Exhibit B
Recommended Amendments to the
2012 International Residential Code
North Central Texas Council of Governments region

The following sections, paragraphs, and sentences of the *2012 International Residential Code* are hereby amended as follows:

****Figure R602.6.1; delete the figure and insert the following figure:**

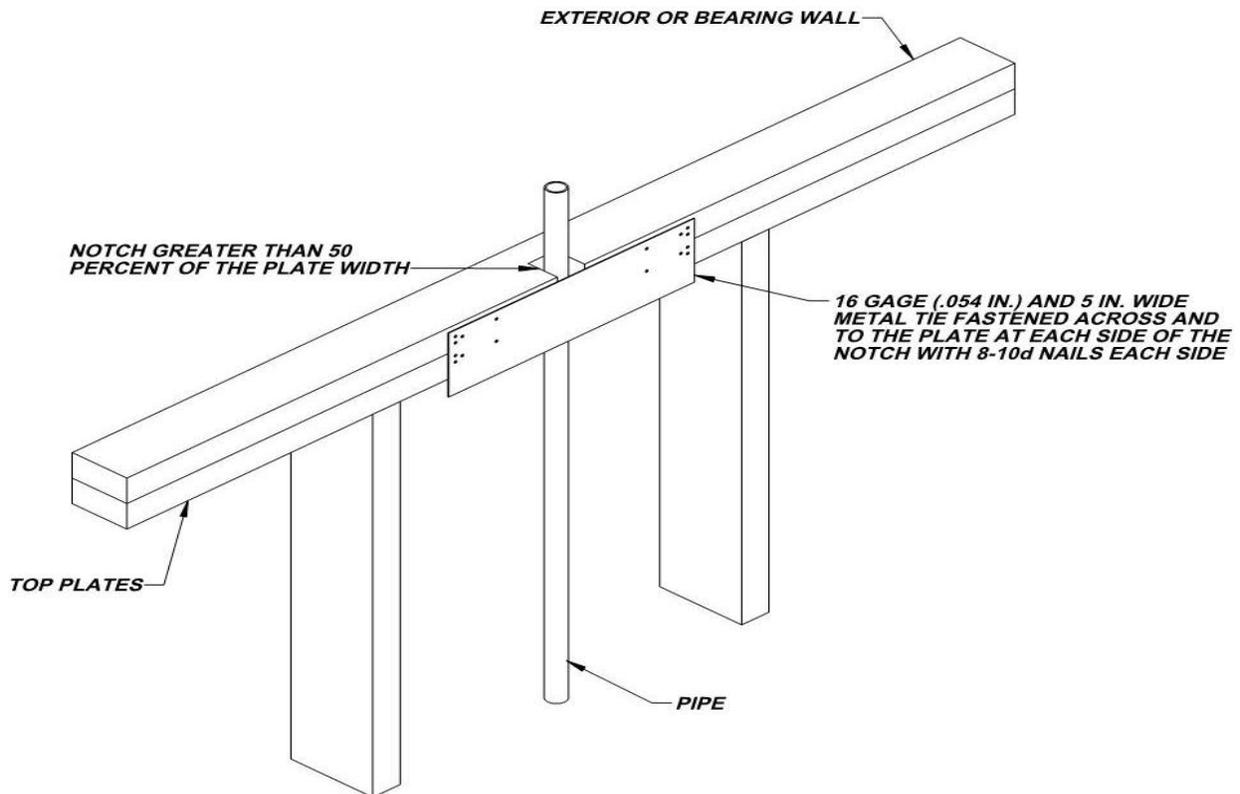
R602.6.1 Drilling and notching of top plate. When piping or ductwork is placed in or partly in an exterior wall or interior load-bearing wall, necessitating cutting, drilling or notching of the top plate by more than 50 percent of its width, a galvanized metal tie not less than 0.054 inch thick (1.37 mm) (16 Ga) and 5 inches (127 mm) wide shall be fastened across and to the plate at each side of the opening with not less than eight 10d (0.148 inch diameter) having a minimum length of 1½ inches (38 mm) at each side or equivalent. Fasteners will be offset to prevent splitting of the top plate material. The metal tie must extend a minimum of 6 inches (152.40 mm) past the opening. See figure R602.6.1. *{remainder unchanged}*
